Access Compliance Report

Public Rights-of-Way

(Pedestrian Signals)

Intersection ID: N/A	Main Street:	Cross Street: N/A	Location: N/A
ADA ID: 9753F18240B4	Signal Type: One Push Button-APS	Overall Compliance: No	Severity Score: BTN 1: N/A BTN 2: N/A No BTN: N/A
Codes/Mitigation Info/Possible Solution		Field Measurements/Component Compliance

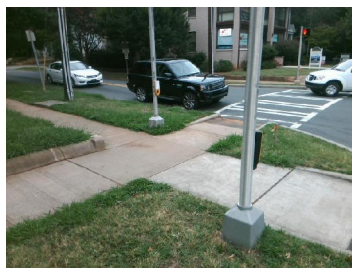
Compliance	Description	Data	Compliance	Description	Data
	Button Count	Button1	Yes	Distant to Additional Button (in)	184.0
	Additional Button Present?	Yes		Additional Button ID	FB2B1D1A74CB
N/A	Signal Buttons Required?	N/A	N/A	Additional Ped Posts Required	N/A
	How Many Ped Street Xings?	1		Located In An Island/Median?	No
N/A	B 1 Sign Present?	Yes	N/A	B 2 Sign Present?	N/A
Yes	B 1 Sign Purpose?	Yes	N/A	B 2 Sign Purpose?	N/A
Yes	B 1 Sign Lettering & Contrast?	Yes	N/A	B 2 Sign Lettering & Contrast?	N/A
Yes	B 1 Parallel To XWalk?	Yes	N/A	B 2 Parallel To XWalk?	N/A
Yes	B 1 PAR to Button?	Yes	N/A	B 2 PAR to Button?	N/A
Yes	B 1 PAR to XWalk?	Yes	N/A	B 2 PAR to XWalk?	N/A
Yes	B 1 Clear Floor Space?	Yes	N/A	B 2 Clear Floor Space?	N/A
N/A	B 1 FWD Approach?	Yes	N/A	B 2 FWD Approach?	N/A
N/A	B 1 FWD Approach Constrained?	No	N/A	B 2 FWD Approach Constrained?	N/A
No	B 1 FWD Approach Reach (in)	11.0	N/A	B 2 FWD Approach Reach (in)	N/A

N/A	B 1 FWD Approach Width (in)	60.0	N/A	B 2 FWD Approach Width (in)	N/A
N/A	B 1 FWD Approach Obstruction?	Yes	N/A	B 2 FWD Approach Obstruction?	N/A
N/A	B 1 FWD Approach Obstruction Dist (in)	9.0	N/A	B 2 FWD Approach ObstructionDist (in)	N/A
N/A	B 1 PARA Approach?	Yes	N/A	B 2 PARA Approach?	N/A
N/A	B 1 PARA Approach Constrained?	No	N/A	B 2 PARA Approach Constrained?	N/A
No	B 1 PARA Approach Reach (in)	11.0	N/A	B 2 PARA Approach Reach (in)	N/A
N/A	B 1 PARA Approach Width (in)	60.0	N/A	B 2 PARA Approach Width (in)	N/A
N/A	B 1 PARA Approach Obstruction?	Yes	N/A	B 2 PARA Approach Obstruction?	N/A
N/A	B 1 PARA Approach Obstruction Dist (in)	9.0	N/A	B 2 PARA Approach ObstructionDist (in)	N/A
Yes	B 1 Clear Floor Space Slope (%)	0.4	N/A	B 2 Clear Floor Space Slope (%)	N/A
No	B 1 Clear Floor Space XSlope (%)	2.5	N/A	B 2 Clear Floor Space XSlope (%)	N/A
N/A	B 1 PAR Slope (%)	4.6	N/A	B 2 PAR Slope (%)	N/A
Yes	B 1 Height (in)	34.0	N/A	B 2 Height (in)	N/A

Yes	B 1 Clear Xing Direction?	ClearlyMarked	N/A	B 2 Clear Xing Direction?	N/A
	B 1 Crossing Direction	To SW		B 2 Crossing Direction	N/A
Yes	B 1 DistanceTo XWalk (in)	0.0	N/A	B 2 DistanceTo XWalk (in)	N/A
No	B 1 DistanceTo Curb (in)	81.0	N/A	B 2 DistanceTo Curb (in)	N/A
Yes	B 1 Diameter (in)	2.0	N/A	B 2 Diameter (in)	N/A

Possible Solutions: Replace Signal Push Button With APS Button on New Post. Remove & Relocate Sign.
